Source: Japan  
Title: A case study for H.310 communication procedures  
Purpose: Discussion and proposal

## 1. Introduction

Figure 1 Mode switching according to Proposal 1

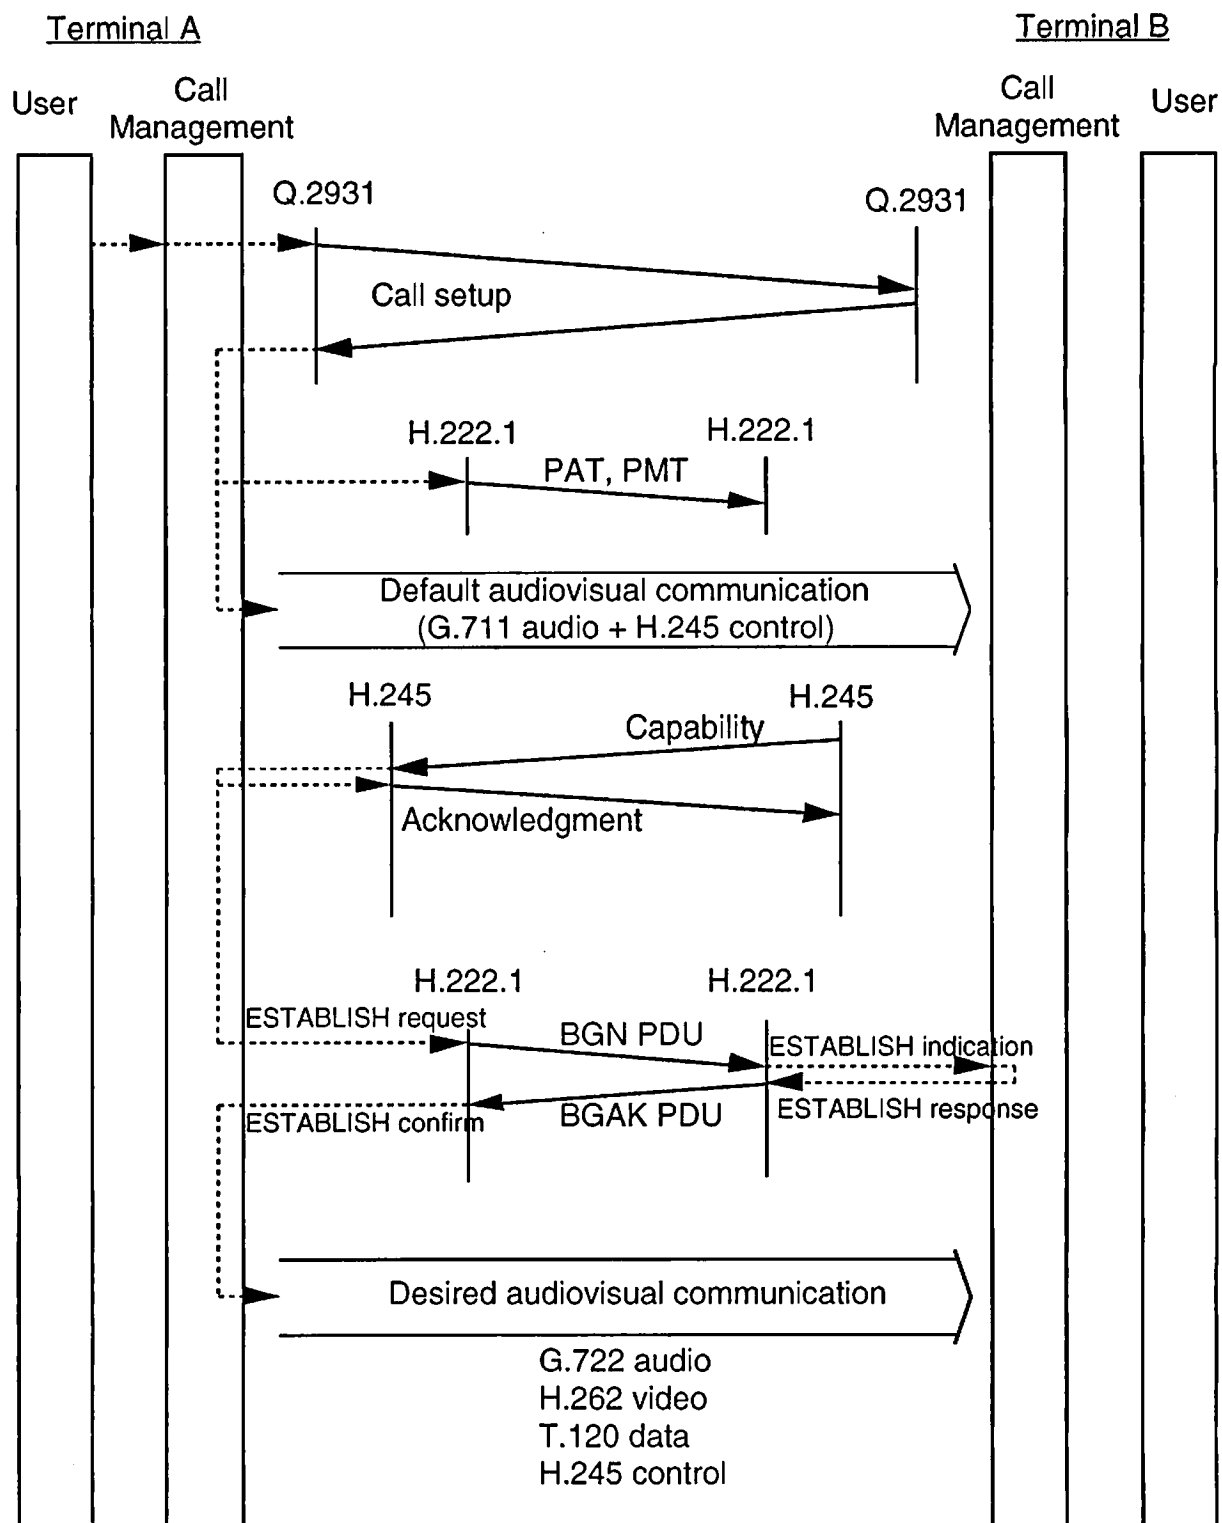
#10 How the default audio is handled?

#11 Control channel is also to be included even if it has already been established with the unacknowledged procedure?

3) H.222.1 outgoing SE sends a PMT containing BGN PDU type. This PMT also contains elementary stream descriptors, thus the incoming side SCSE can identify whether it has necessary decoding resources.

# (S D) *This is not quite right. It is not the receive side SCSE which knows about decoding resources, but the receive side CM above it. Remember that the receive side CM decides whether or not to accept the set up request, based upon its knowledge of the terminal resources. H.222.1 only has knowledge of which logical channels are in use.*

# (S D) *In the above I am not sure what a "descriptor becoming effective" means.*

#12 At this point, no video (PID=0011 h), G.722 audio (PID=0012 h) nor data (PID=0013 h) packets are in the H.222.1 bitstream? Only G.711 audio (PID=0020 h) and Control (PID=0014 h) are in the bitstream?

#13 PCR\_PID has been changed from G.711 Audio to Video PID. Do we need some provisions for this change?

*# (S D) Assuming no default audio logical channel, the first H.222.1 signalling phase sets up such a logical channel. The logical channel can be released at this stage if it is no longer required.*

# (S D) *If the control channel is already established then it is not included here.*

# (S D) *Correct.*

Figure 2 Mode switching according to Proposal 2

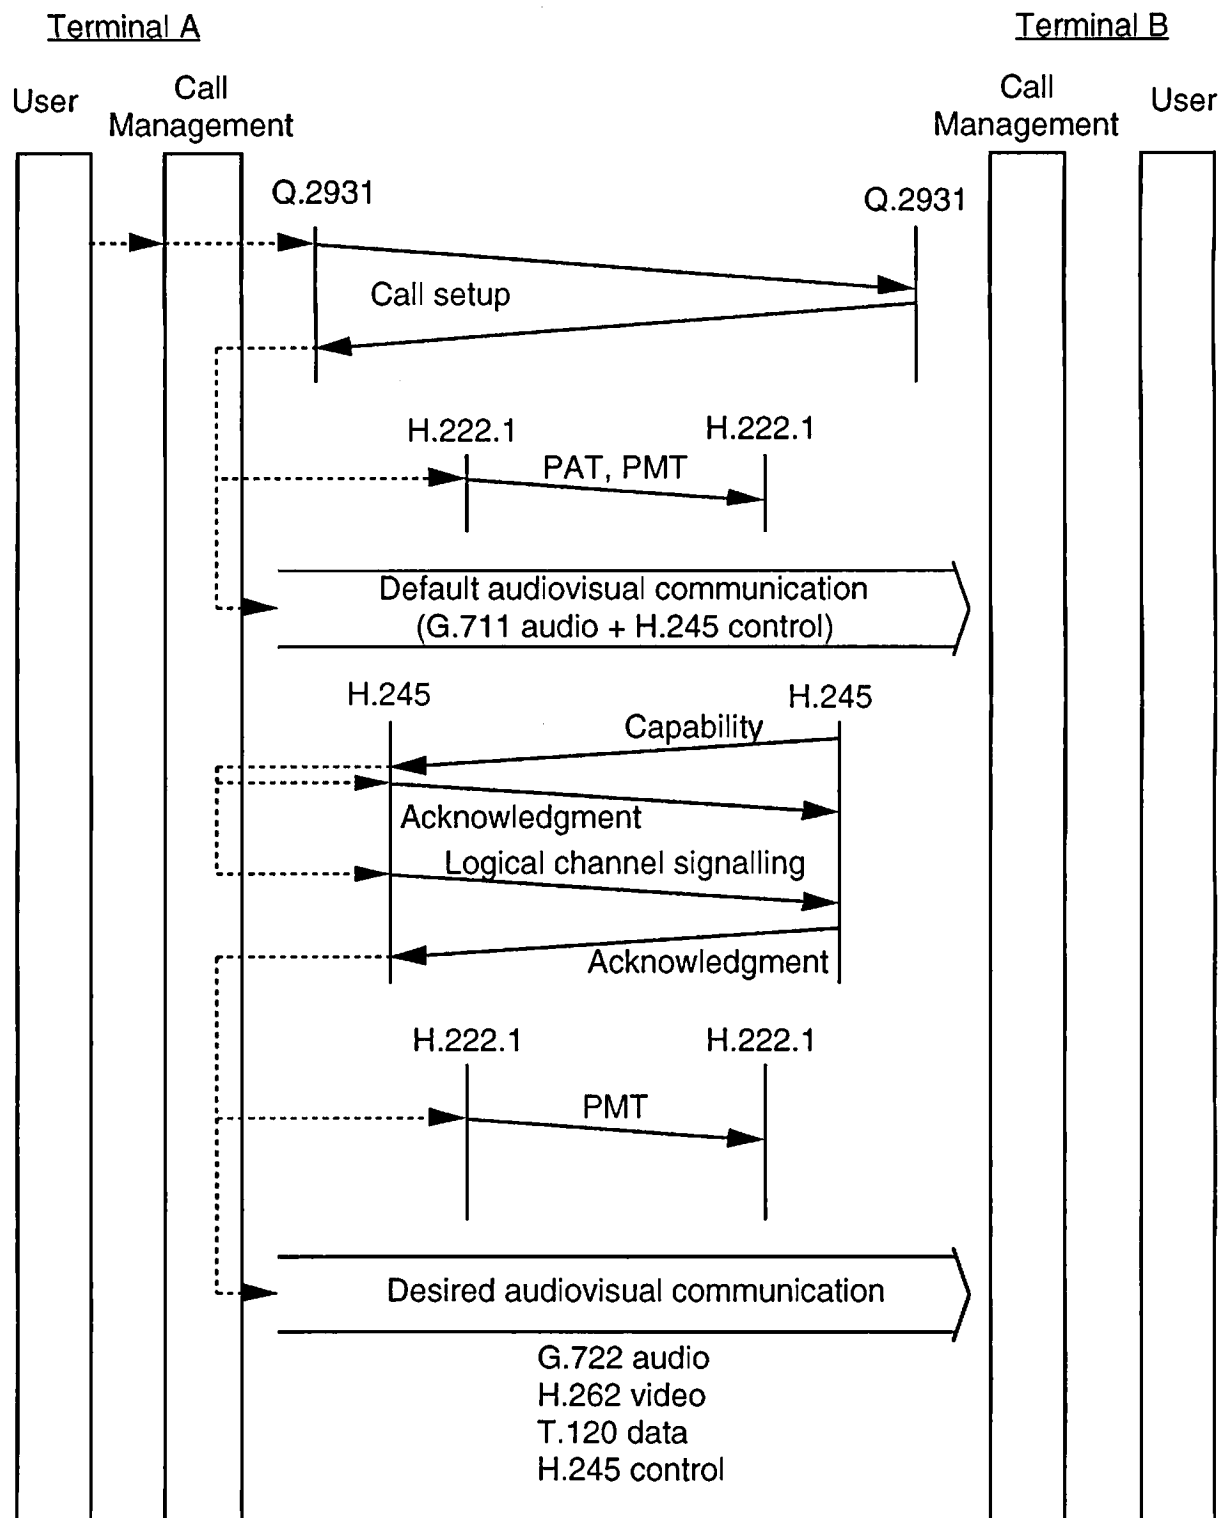
# (S D)      *Proposal 2 appears to be using both H.245 and H.222.1 for logical channel signalling.*

*For reliable operation Proposal 2 still requires acknowledgement for the PAT and PMT tables. Nothing appears to have been gained by moving some of the signalling to H.245.*

# (S D)      *I don't agree with this last sentence for the previously stated reasons.*

#22      Is this nesting correct? Or the nesting be under messageType?

#23      For Audio (logicalChannelNumber = 18 d), messageType should be channelSetUp (PID) or channelRedefinition? channelRedefinition is used for the same logicalChannelNumber whose content is switched from one audio to another or from audio to video?

#24      For the default Audio and Control logical channels, no such logical channel signalling messages are sent?
